CHANGE ORDER BREAKDOWN

Description of work: This change order has been generated in response to RFI 45. RSD will remove and relocate S-127A to tie into existing unmarked/unknown drainage at 3rd street. Cost - Relocate structure, MOT, Maintenance of the road.

CO #: 34 R2

Project Name: Barfield Highway Reconstruction - Fin. Proj.ID#442030-1-54-01
Proposal #: 123008
Location: 370 South Barfield Highway
 Pahokee, Florida 33476
Latitude: 26.8191525 **Longitude:** -80.6612582
County: Palm Beach County
Prepared for: Rosso Site Development, Inc
Contact: Joseph Rosso III

RFI 45

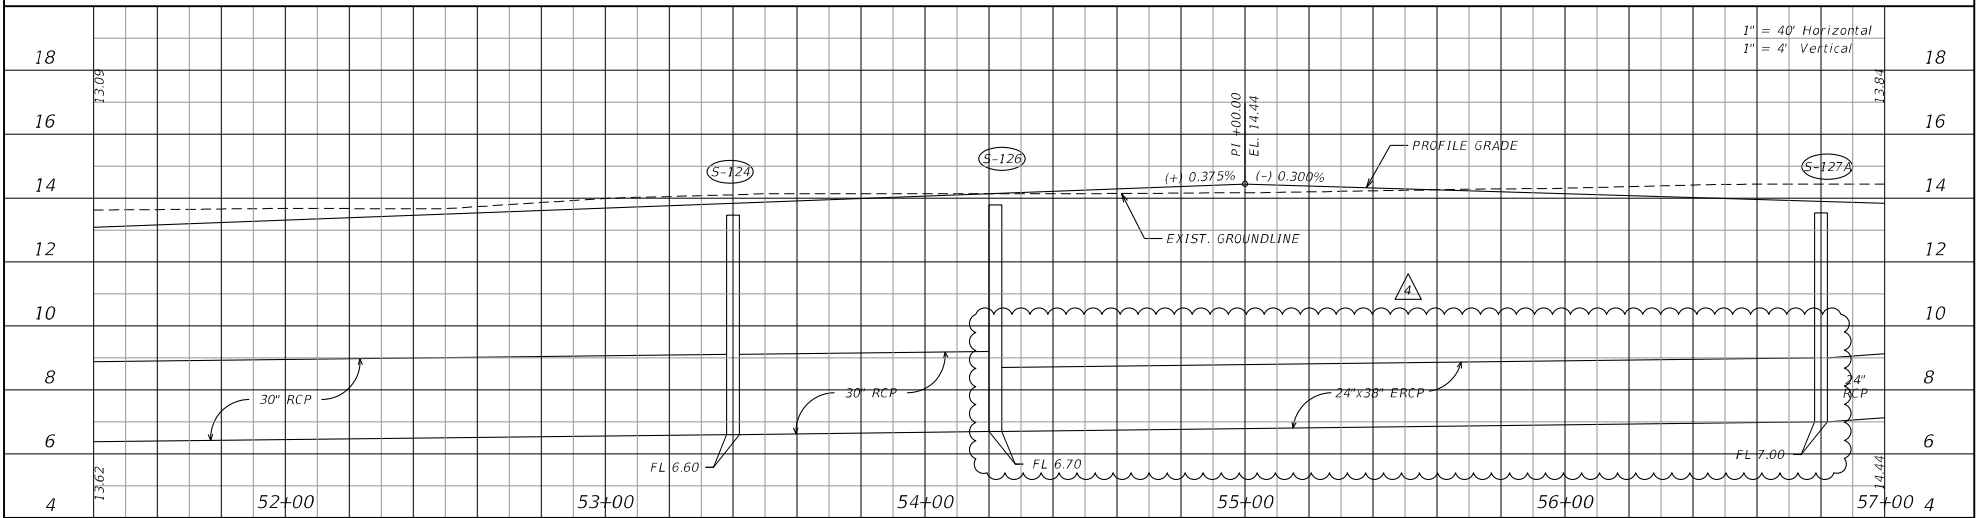
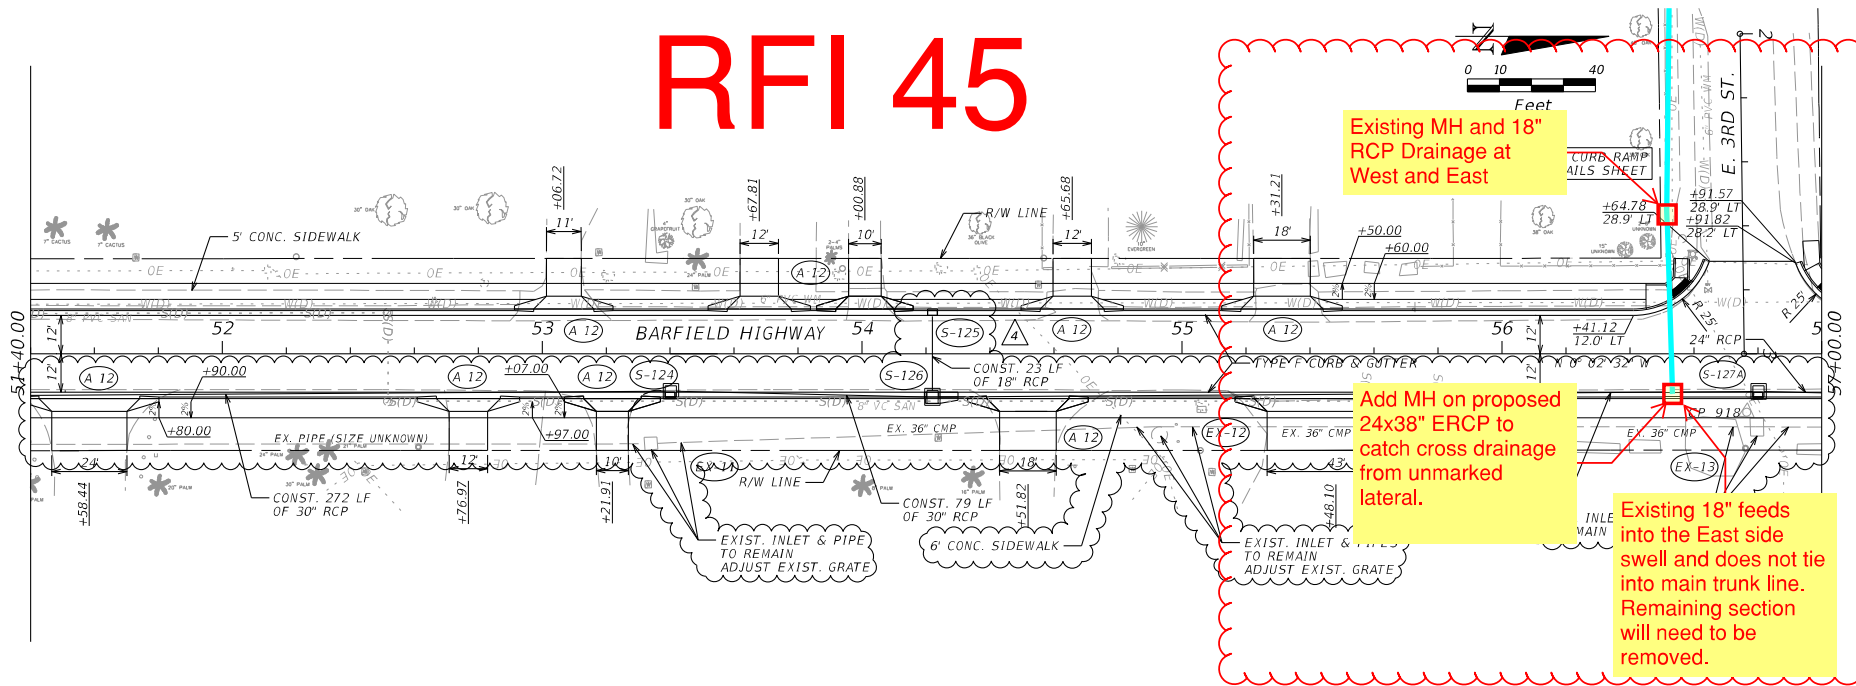
See Johnson Davis RFI regarding Existing Drainage Conflict at 3rd St.

See attached drawing from the field on how to proceed with the conflict at 3rd Street. Johnson-Davis is proposing an additional Square Box to be added within the new truck line of 24"x28" ERCP to accomadate the existing drainage coming in from the West. Please advise.

Move S-127A to the pipe location. See email
Response below.
Robert Audette, PE

I would recommend to relocate S-127A to that location, so we don't need a new manhole. I'm not in front of my computer, so I will look into it tonight and confirm.
